**IN THE DRAWINGS:**

**Attachment:            Replacement Sheet 2/11, 3/11, 5/11, and 11/11**  
**Annotated Sheet Showing Changes 2/11, 3/11, 5/11, and 11/11**

ATTY DKT. No.: APPM/008348/MASK/MASK-ETCH/ARNOLD S  
 U.S. SERIAL No.: 10/689,783 CONF. No.: 7569  
 FILED: OCTOBER 21, 2003  
 APPLICANT: APPLIED MATERIALS, INC.  
 TITLE: MASK ETCH PROCESSING APPARATUS  
 INVENTORS: NGUYEN, ET AL. PAGE 2 OF 11

FIG. 2

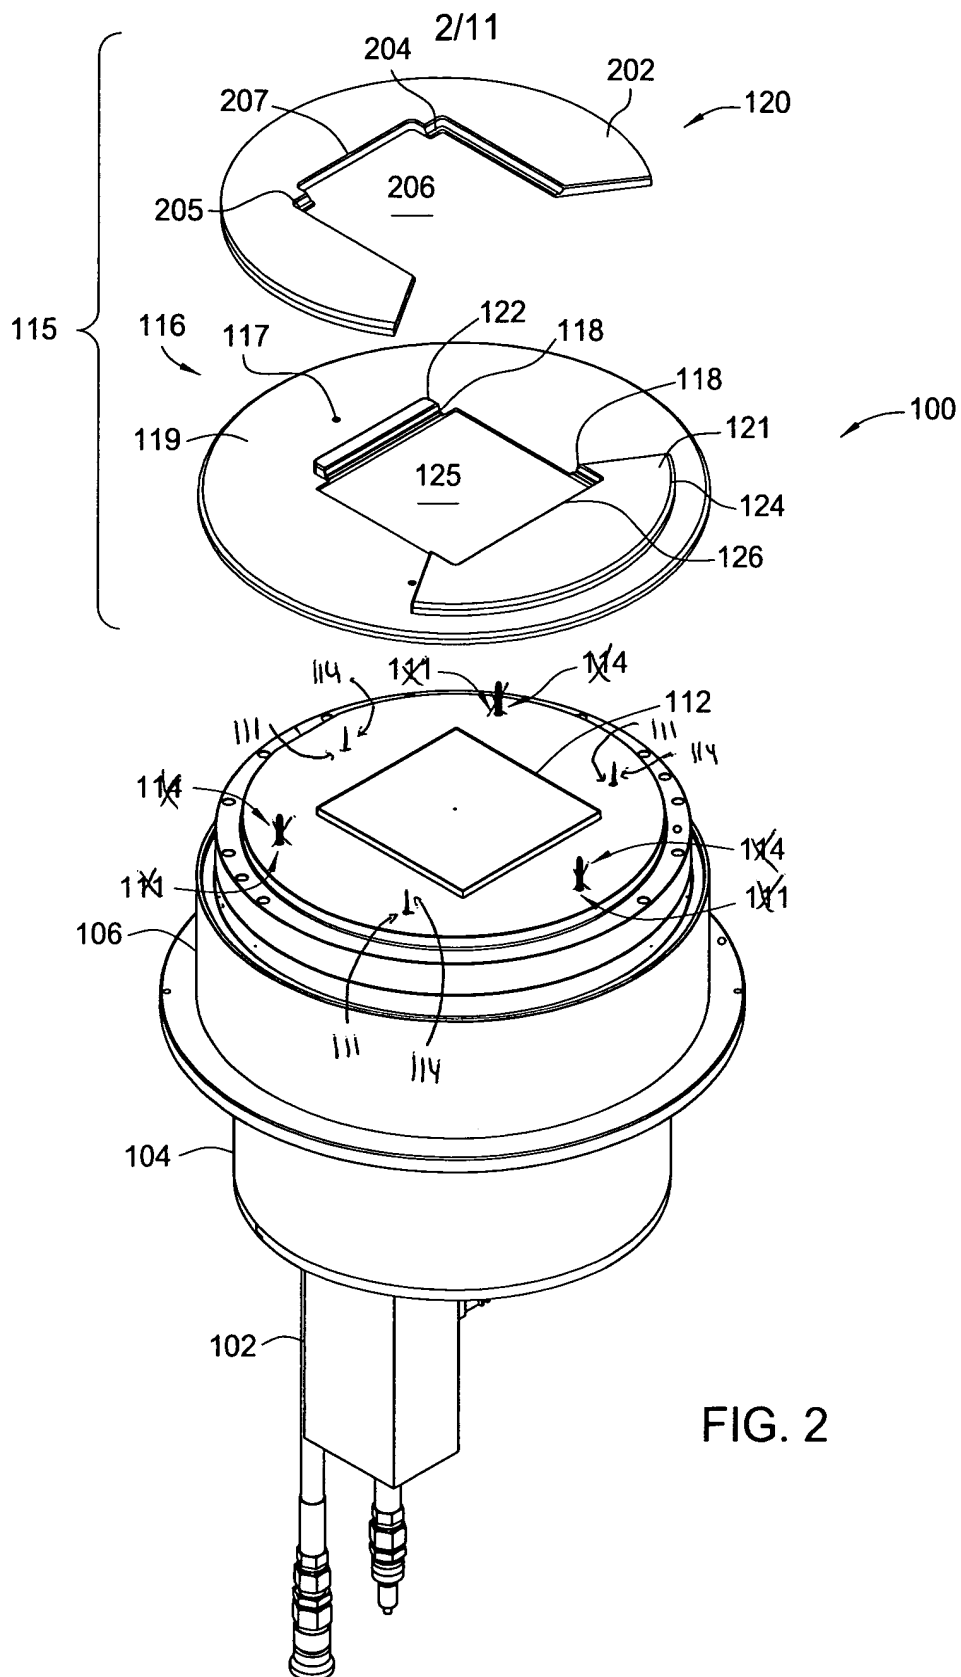
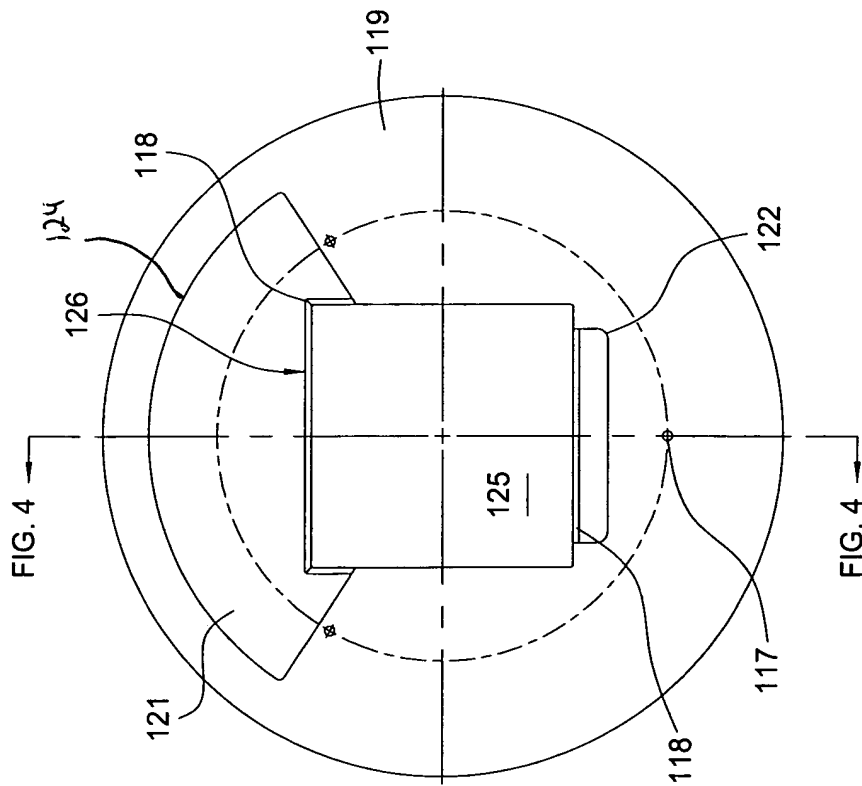
FIG. 2 has been amended. The channels 111 and lift pins 114 have been moved to be aligned with the channels 117. Support for the amendment is shown in Figs. 9-13.

FIG. 7

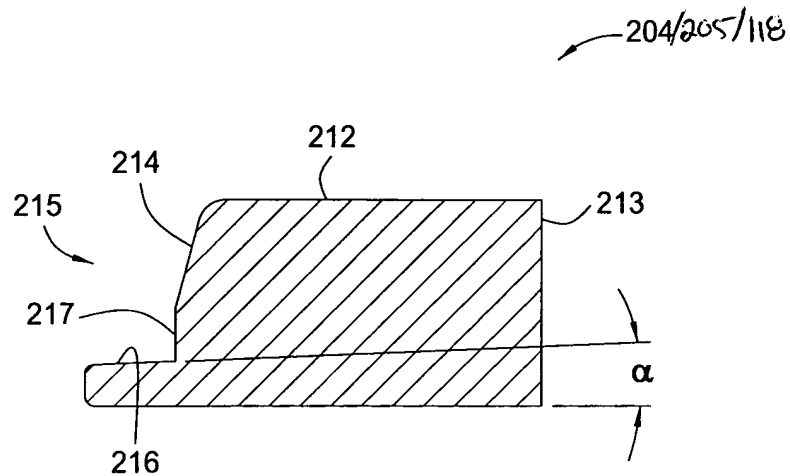
FIG. 7 has been amended. Previously omitted elements 205 and 118 have been added.

FIG. 14

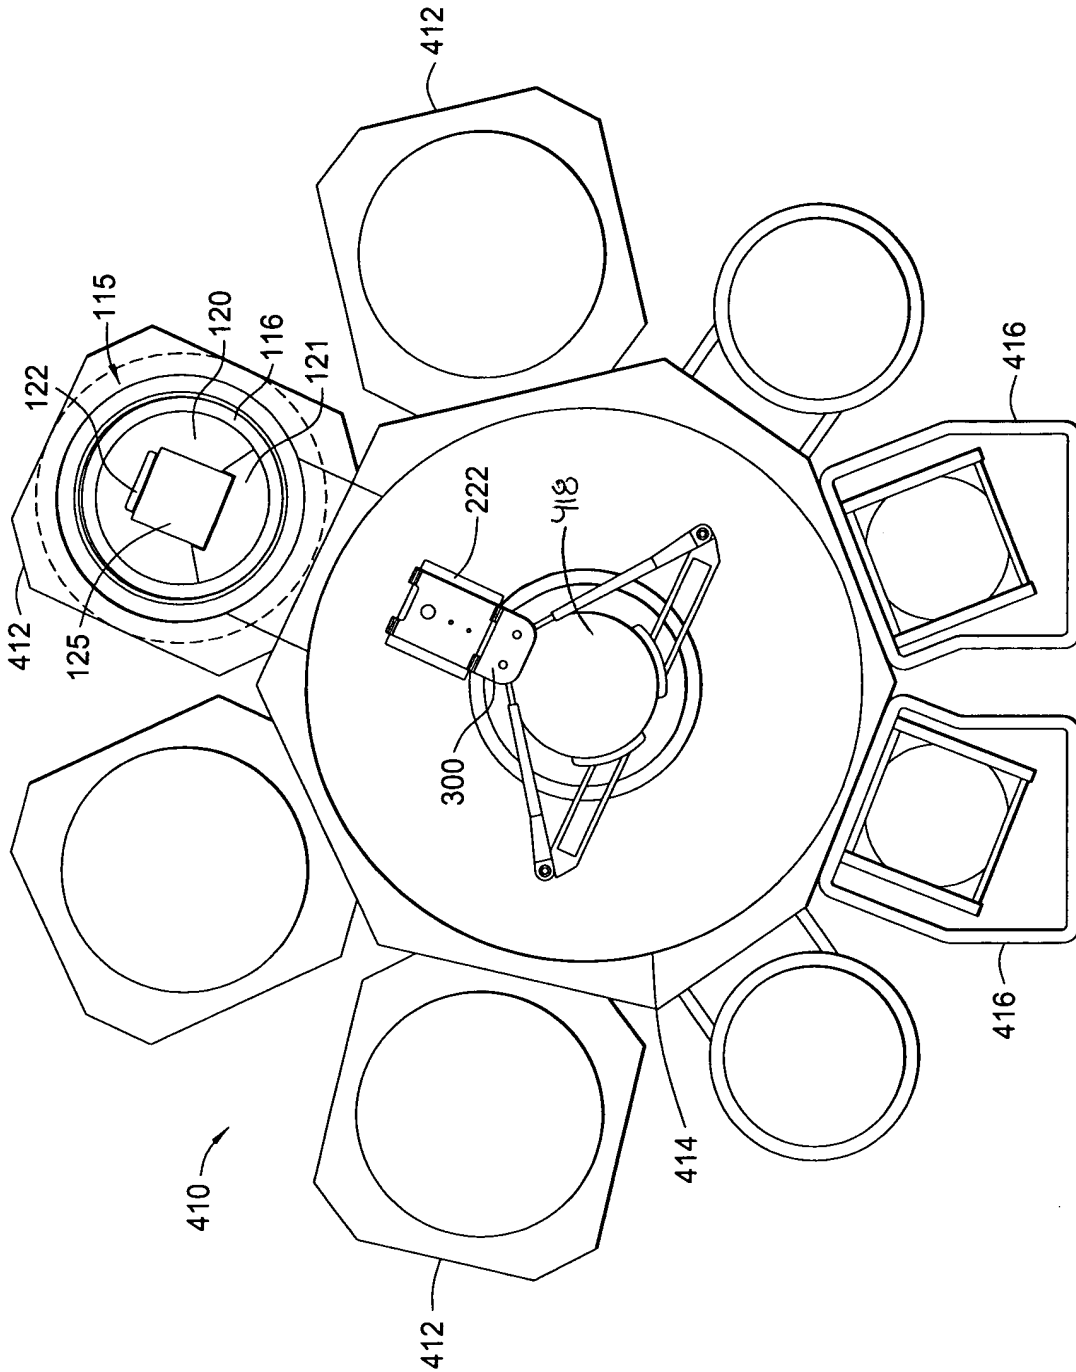
FIG. 14 has been amended. Previously omitted element 418 has been added.
